ARCHITECT'S SUPPLEMENTAL INSTRUCTION NO. 5

DATE: February 19, 2024 **PROJECT NO:** 230117

RE: Streets of West Pryor – Lot 5 Core & Shell

SHEET NUMBER
G-001

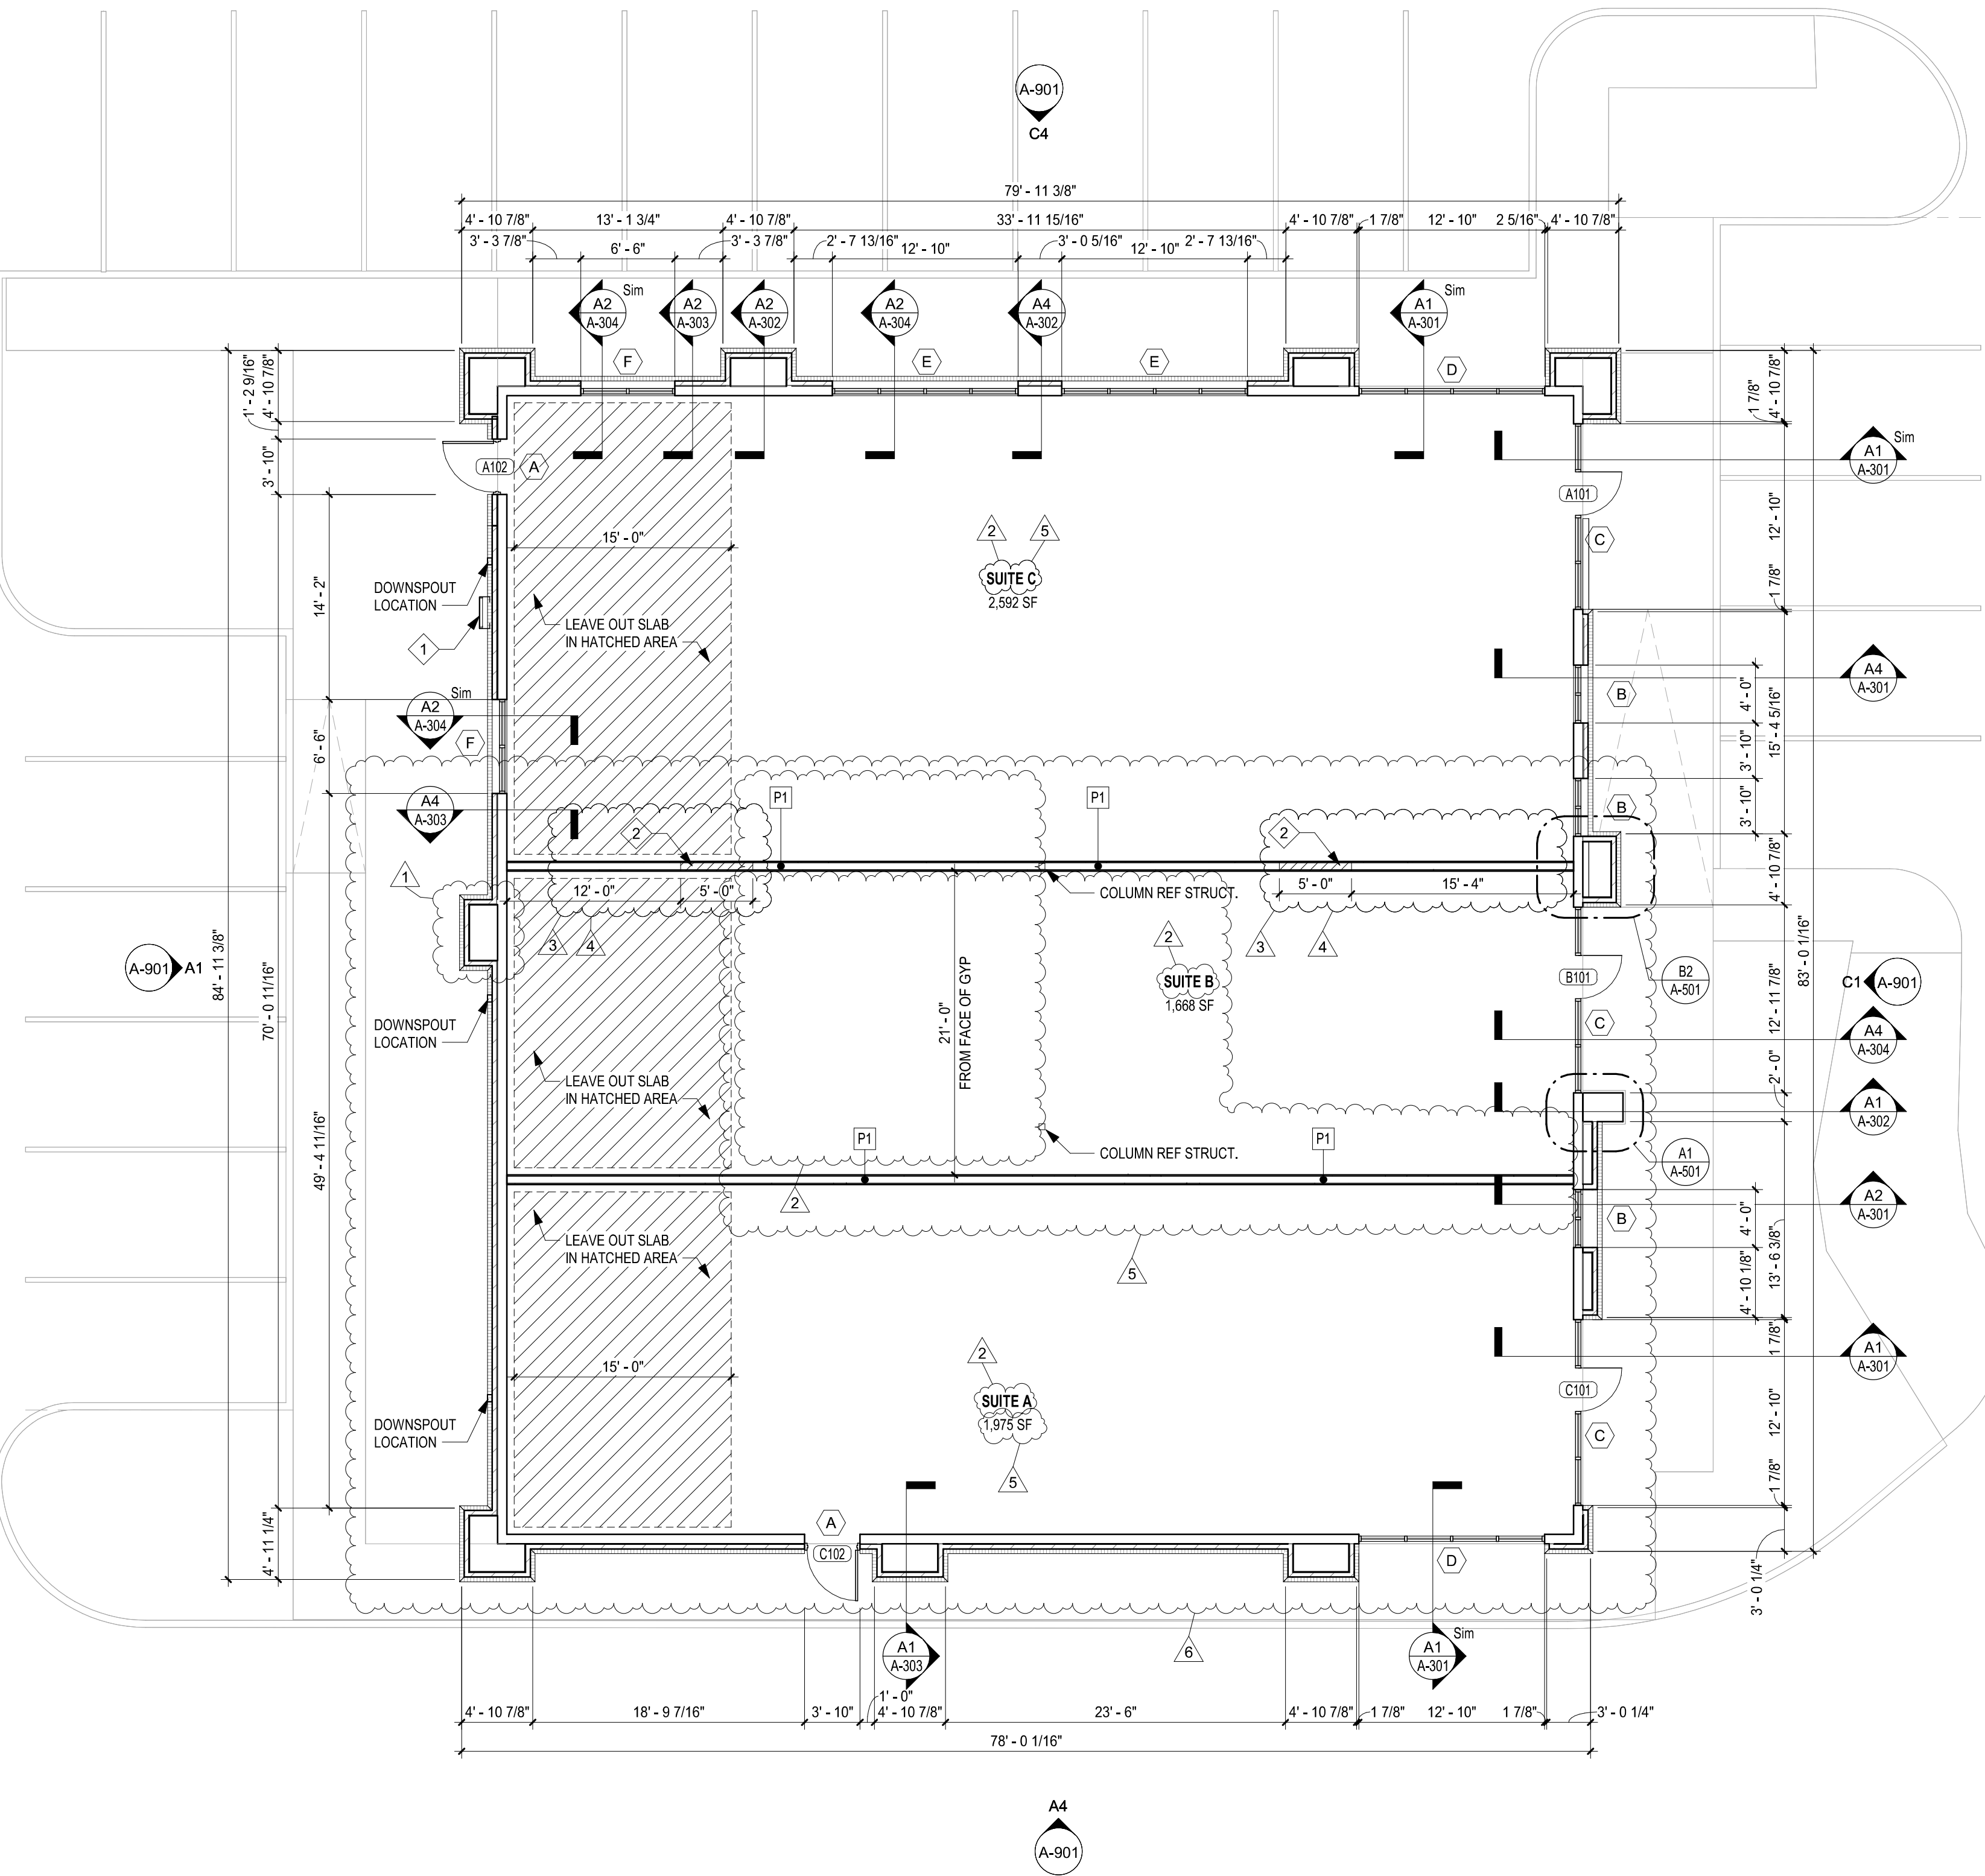
- A-1 Sheet G-001 – Code summary updated with usable square foot occupant load calculations and exit requirements for tenant suites A, B & C.
 - A-1.1 Sheet G-001 – Code plan updated with occupant load calculations and egress width for tenant suites A, B & C.
- A-2 Sheet A-101 – Two hour rated demising wall added to full East to West length of the building spaced 21 feet from face of gypsum board to the other second two hour rated demising wall. Creating and dividing the Core & Shell building into now three separate tenant suites.
 - A-1.A Updating tenant suite designations as Suite A, B & C respectively.
 - A-1.B Updating tenant suite square footage.
- A-3 Sheet A-102 – Roof Top Unit added to service enlarged Tenant Suite B space.

SHEET NUMBER
A-101

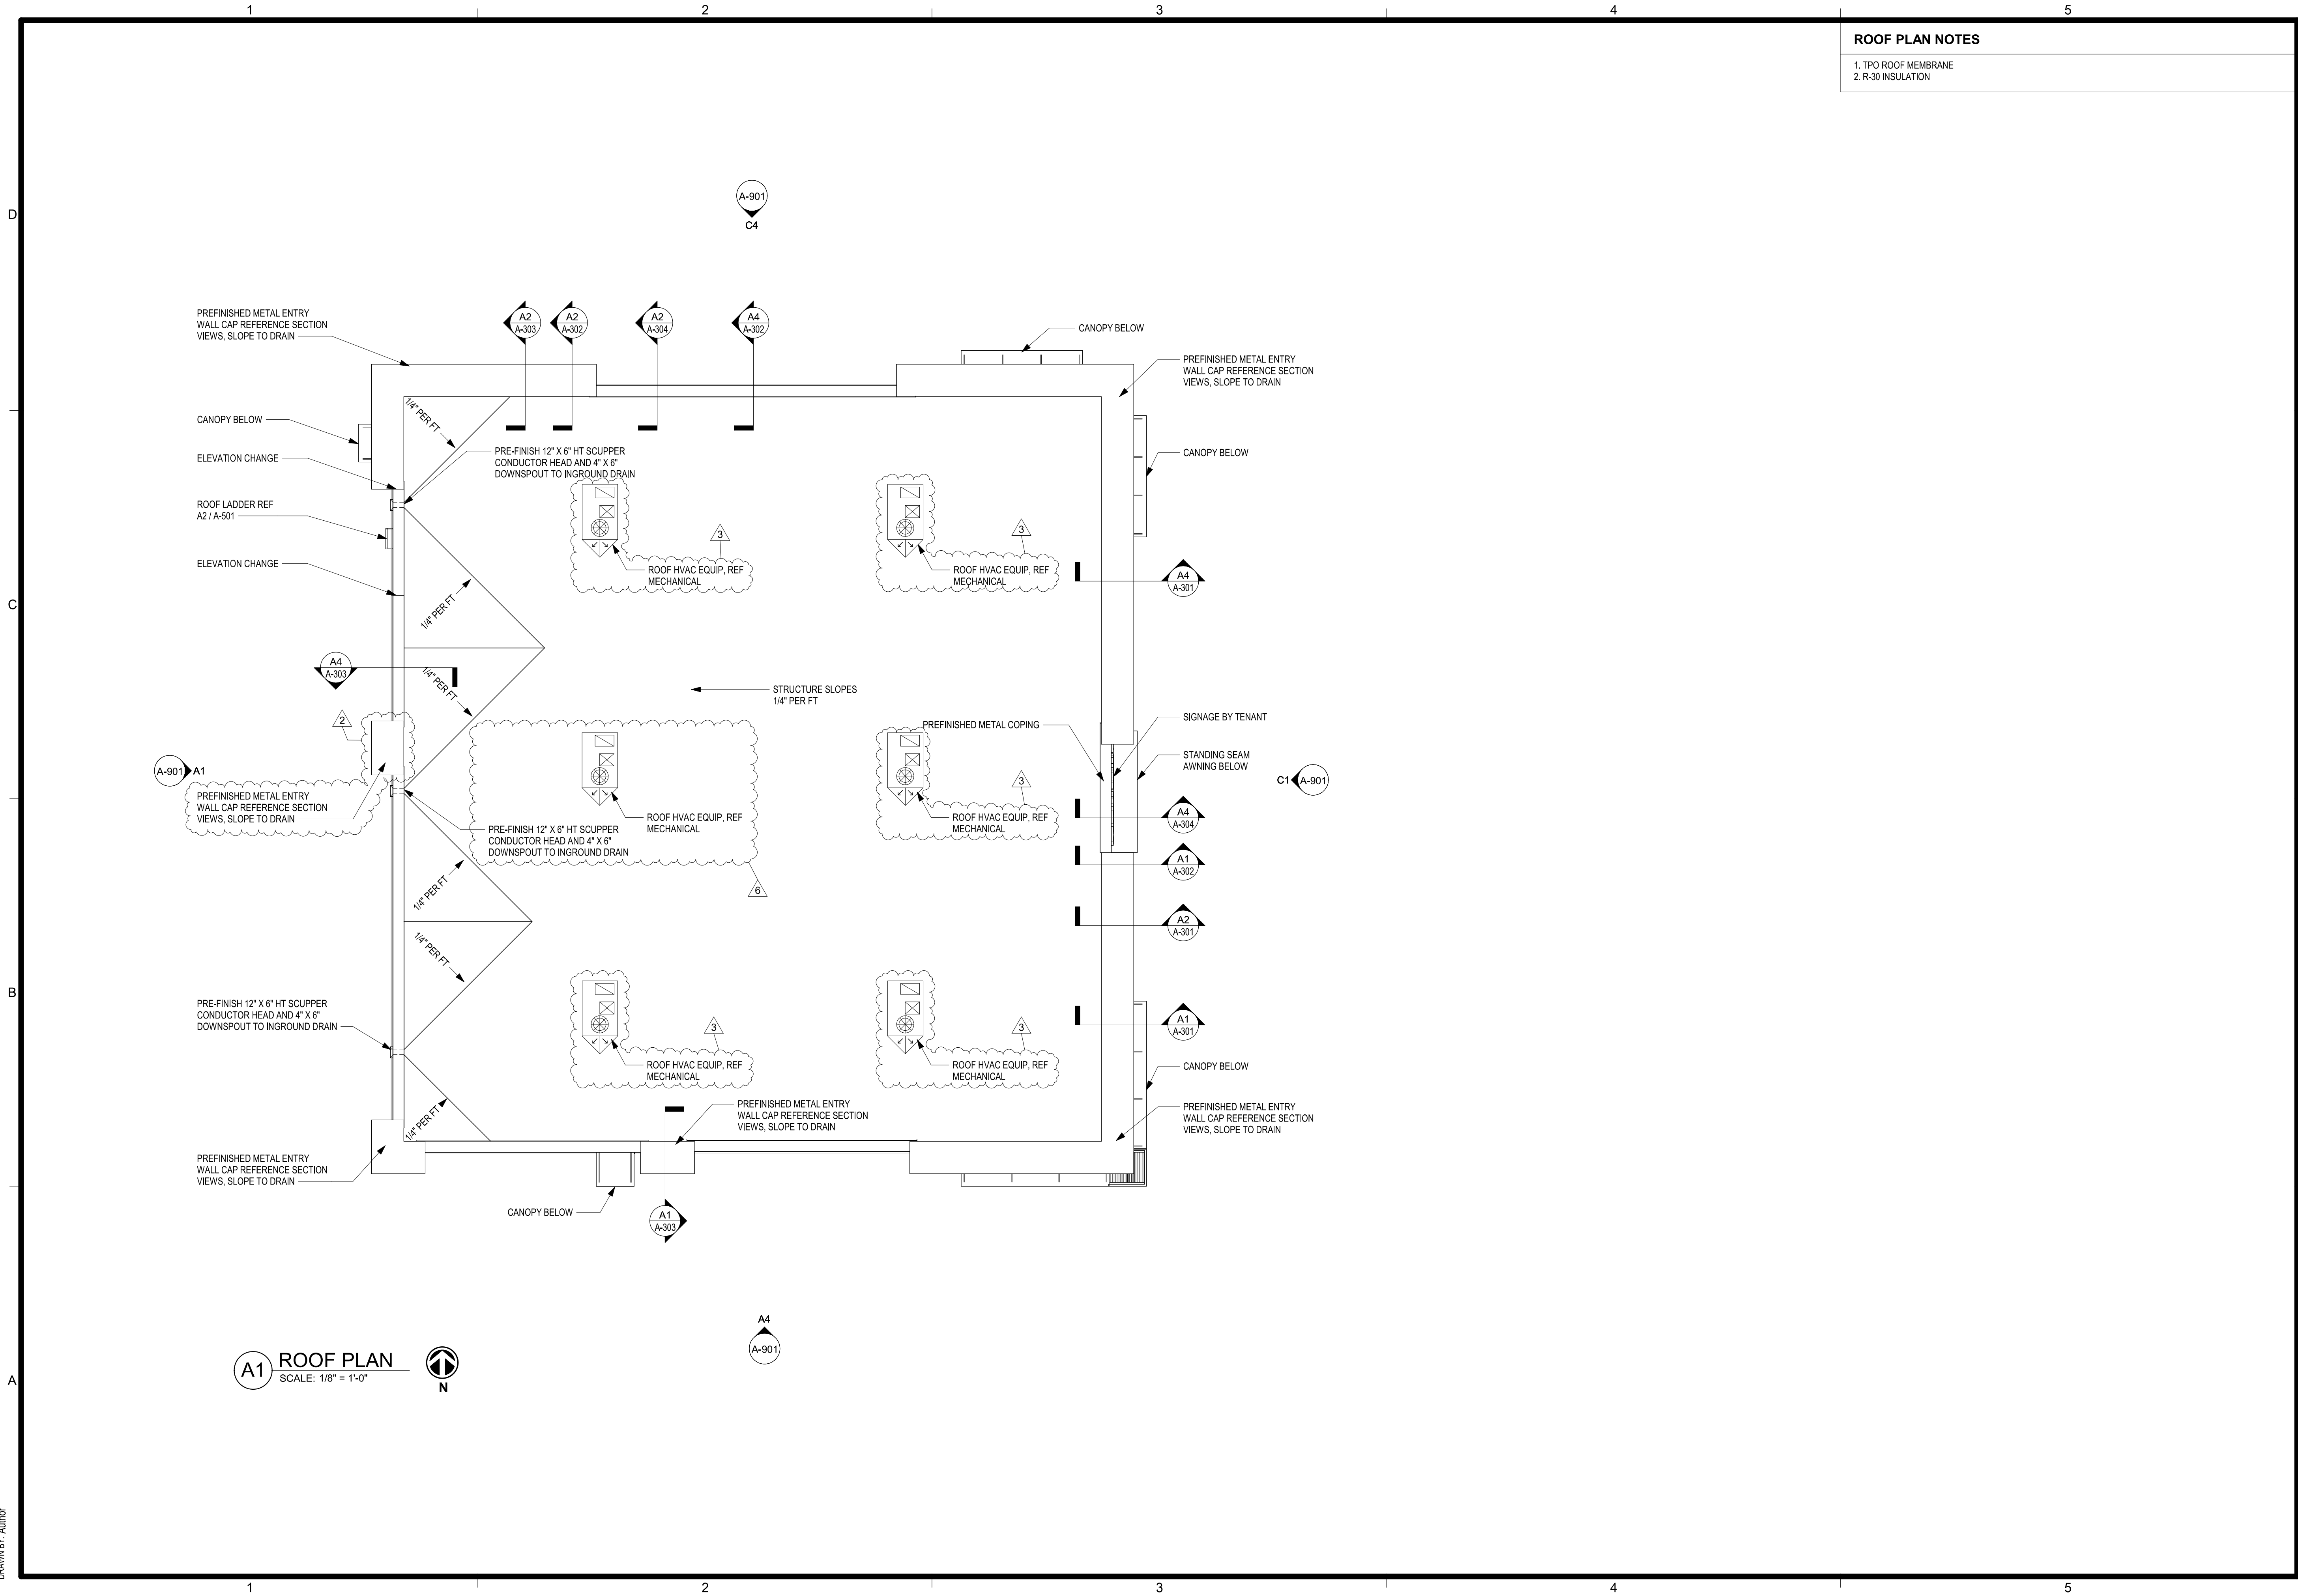
A-1 Sheet A-101 – Updated location of future pass-through openings on Suite C's South demising wall.

- A-1 Sheet A-101 – Future pass-through openings added on East and West ends of Suite C's South Demising wall.
 - A-1.A - Key plan note #2 for Future pass-through added to Keyed Plan Notes legend.
- A-2 Sheet A-102 – RTUs rotated 90 degrees for structural support purposes.
- A-3 Sheet A-201 – Door C101 update to be 7' and Tempered Glass.
 - A-3.A - Reference to MEP exterior utilities indicated on West Elevation Drawing A1.
- A-4 Sheet A-601 – Door schedule updated to represent C101 door as 7' and Tempered Glass.
